VIRGINIA ELECTRIC AND POWER COMPANY
RICHMOND, VIRGINIA 23261

AMENDMENT TO OPERATING LICENSES DPR-32 AND DPR-37
SURRY POWER STATION UNITS 1 AND 2
PROPOSED TECHNICAL SPECIFICATIONS CHANGE

SAFETY EVALUATION FOR
REDUCTION IN BORON CONCENTRATION
IN THE BORON INJECTION TANK AND
CONCENTRATED BORIC ACID SYSTEM

SURRY POWER STATION

FIGURE 1

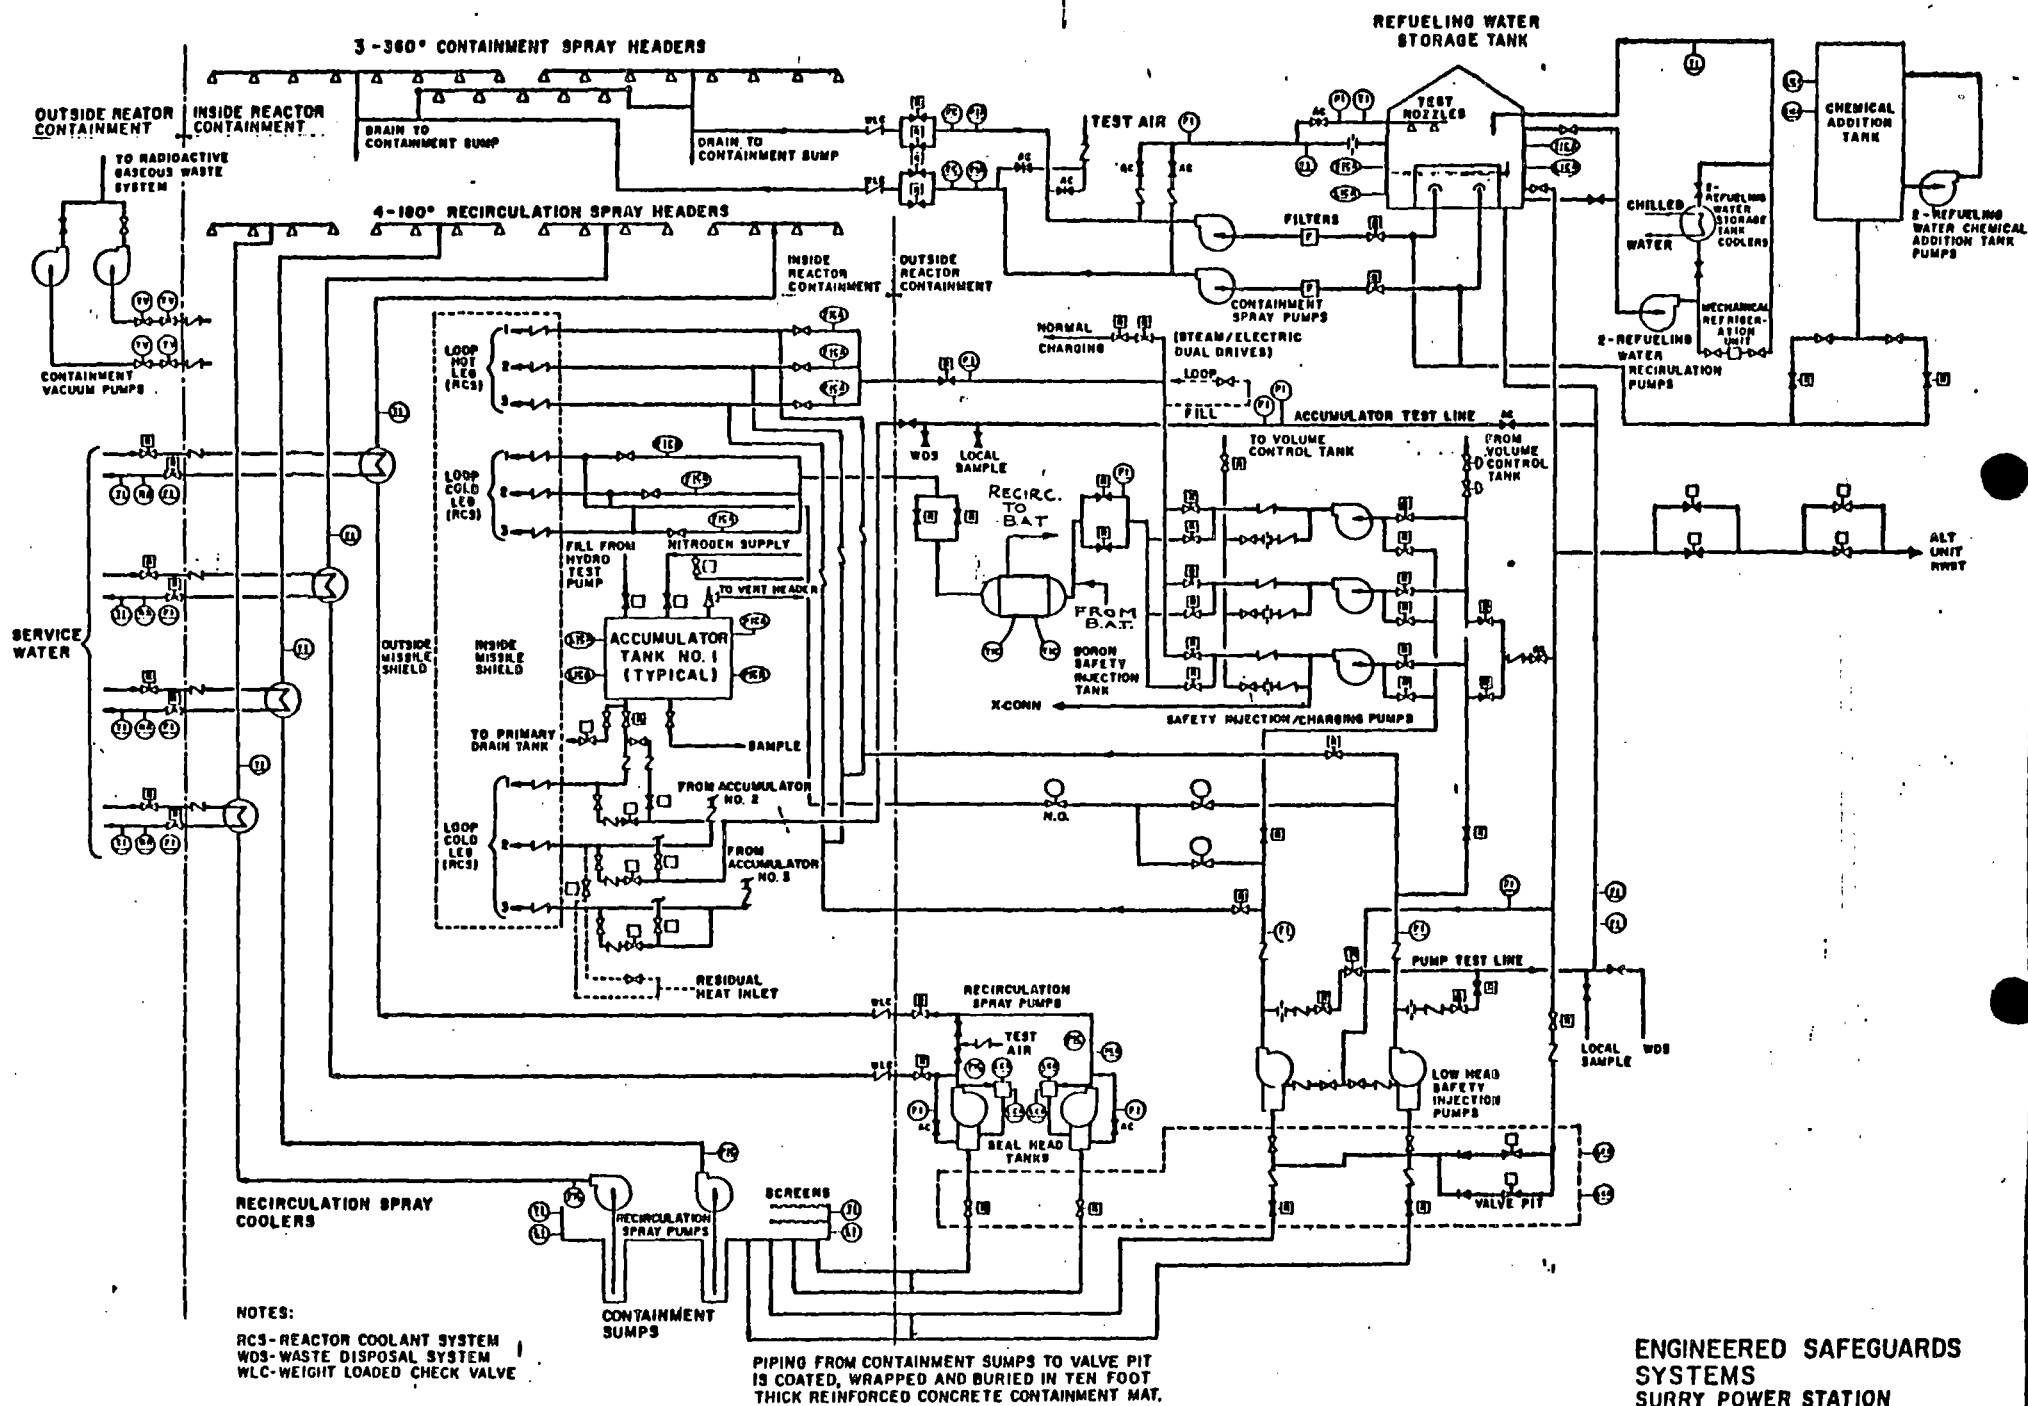
The Boron Injection Tank (BIT) is a 900 gallon carbon steel tank which is internally clad with stainless steel and is part of the Safety Injection System; it contains boric acid solution at a minimum of 11.5% by weight boric acid. Redundant tank heaters and line heat tracing are provided to maintain a minimum solution temperature at a Technical Specifications limit of 145 degrees F, thus preventing boron plateout. Recirculation from the BIT to the Boric Acid Tanks is maintained continuously via a Boric Acid Transfer Pump to ensure the BIT is full of concentrated boric acid at all times and to prevent cold spots and stratification within the tank. The BIT is isolated from the Reactor Coolant System and the Charging Pumps during normal plant operation by two sets of parallel isolation valves. Figure 1 illustrates the system design as described above.

Current plans are to reduce the required boric acid concentration in the BIT to 0% with only a minor physical modification to the plant. This modification would entail (1) cutting the recirculation lines (to the BAT and Volume Control Tank) and welding the ends closed to ensure concentrated boric acid will not leak from the Boric Acid Tank to the BIT and (2) removal of electrical power to the recirculation line isolation valves. Electrical power will also be terminated to the BIT heaters and heat tracing circuits of the recirculation lines. The BIT would remain in place. All other system components will remain unaffected, including the actuation of the BIT inlet and outlet isolation valves.

FIGURE 2
BORIC ACID SYSTEM

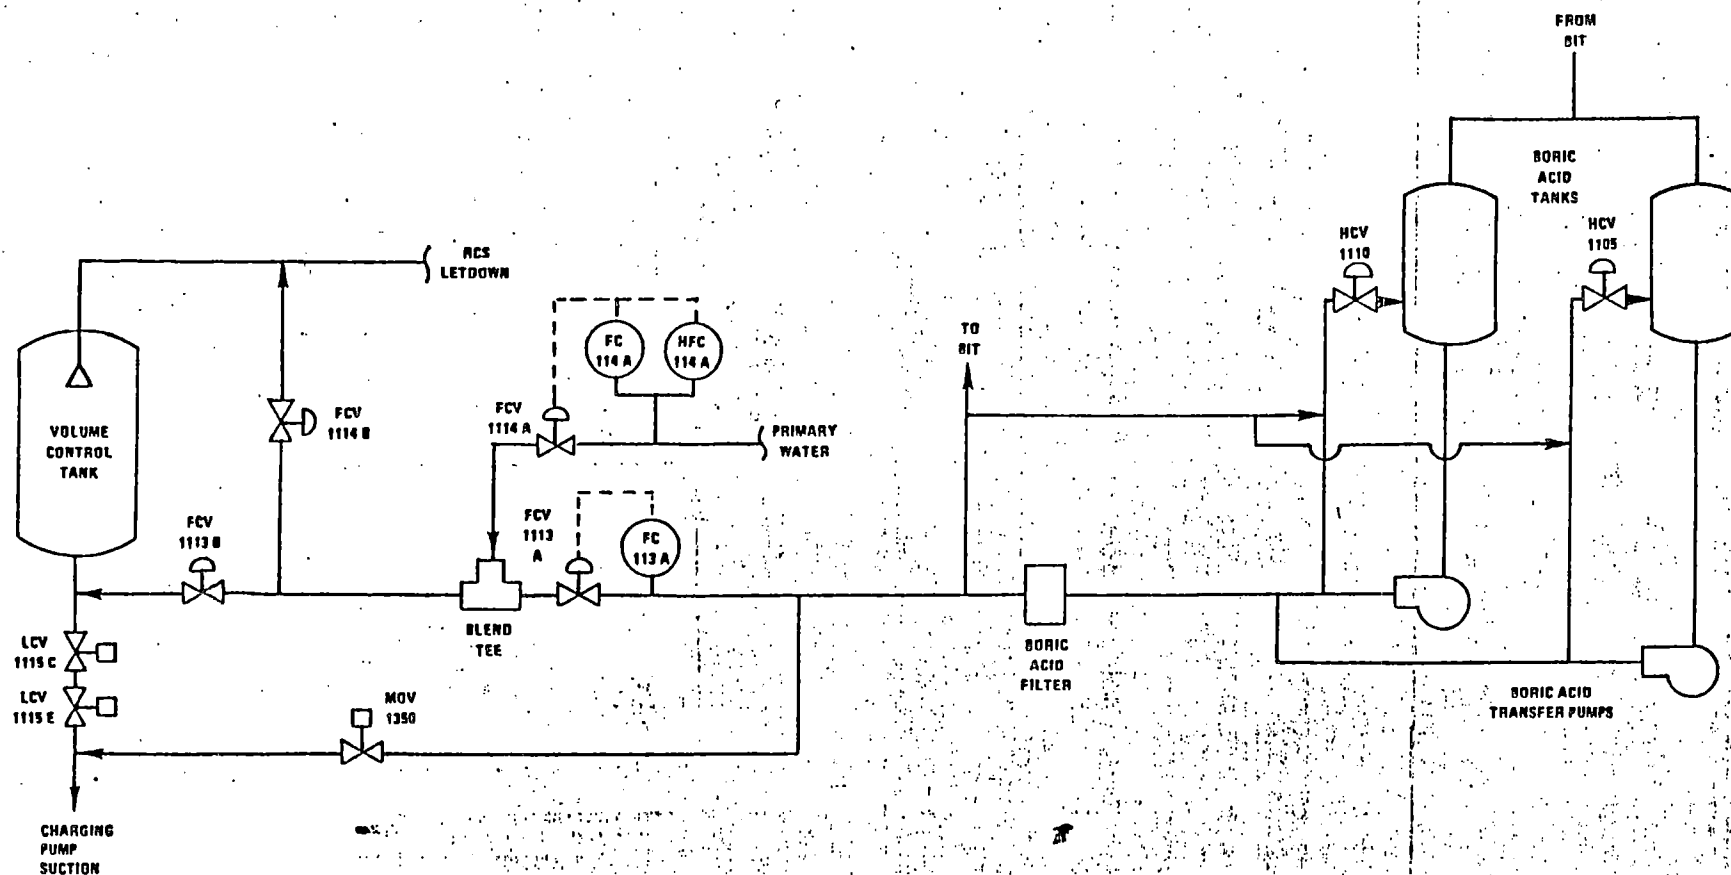
The concentrated boric acid system is a part of the Chemical and Volume Control System described in Section 9.1 of the Updated Final Safety Analysis Report. The purpose of the system is to provide an inventory of concentrated boric acid for (1) chemical shim reactivity control, (2) providing makeup to the Reactor Coolant System, Refueling Water Storage Tank, spent fuel pit and refueling cavity as necessary and (3) recirculation of boric acid through the BIT via the boric acid transfer pumps. The system consists of three Boric Acid Tanks, four boric acid transfer pumps, one batch tank, boric acid filters and associated piping, valves, heat tracing, controls and instrumentation. The Boric Acid Tanks are sized to provide sufficient boric acid to bring the reactors to cold shutdown conditions assuming a stuck control rod. A simplified schematic of the system is shown in Figure 2.

Reduction in the boron concentration requirement for the Boric Acid system to 7% will require increasing the minimum volume of boric acid stored for each operating unit to 6000 gallons. This can be accomplished by resetting the existing level instrumentation and alarms for the new minimum low level. With this increase in volume requirement for each unit, the capability to bring the units to cold shutdown conditions with the most reactive control rod assembly withdrawn from the core is preserved. BAT heater controls and the system heat tracing controls will be reset to maintain a minimum temperature of 112 degrees F to maintain solution solubility.

1. Reset Boric Acid Tank level instrumentation and alarms for a minimum volume of 6000 gallons.
2. Reset BAT heater and heat tracing controls to maintain a minimum solution temperature of 112
